T10/05-079r0 SAS-1.1 Minimum XR/IR Receiver Signal Level for 3Gb SATA Mode

To: T10 Technical Committee
From: Barry Olawsky, HP (barry.olawsky@hp.com)
Date: 22 February 2005
Subject: T10/04-079r0 SAS-1.1 Minimum XR/IR Receiver Signal Level for 3Gb SATA Mode

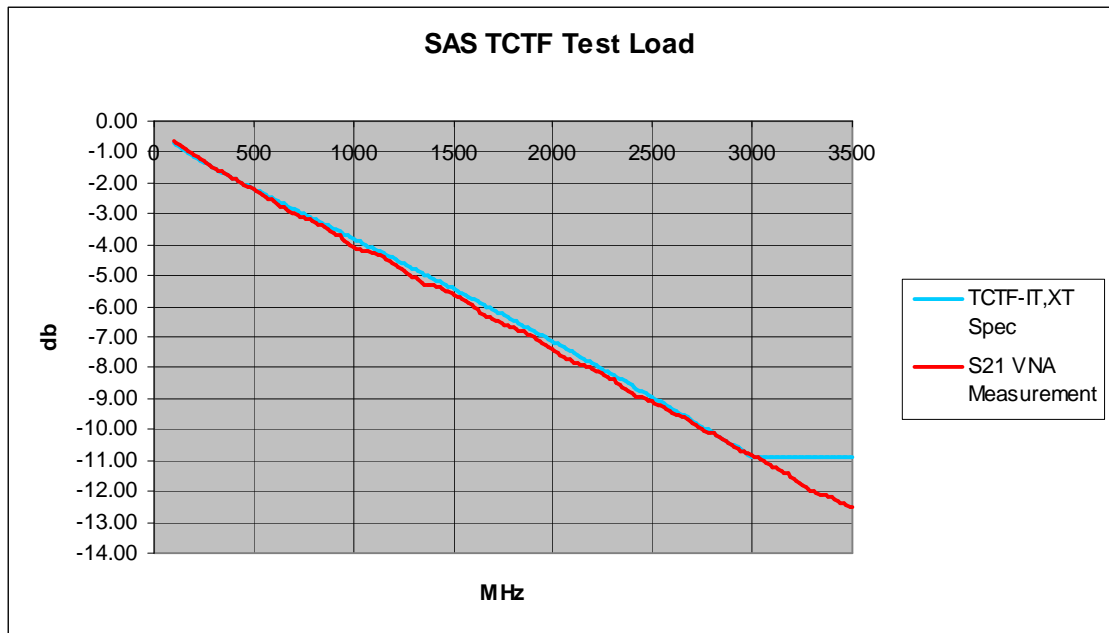
Determine expander/initiator receiver threshold requirements when using SATA II compliant 3Gb devices. If proposed receiver specifications are not feasible, define a lower loss TCTF for use with SATA devices.

Modify the minimum XR/IR receiver signal level specified for 3Gb SATA mode.
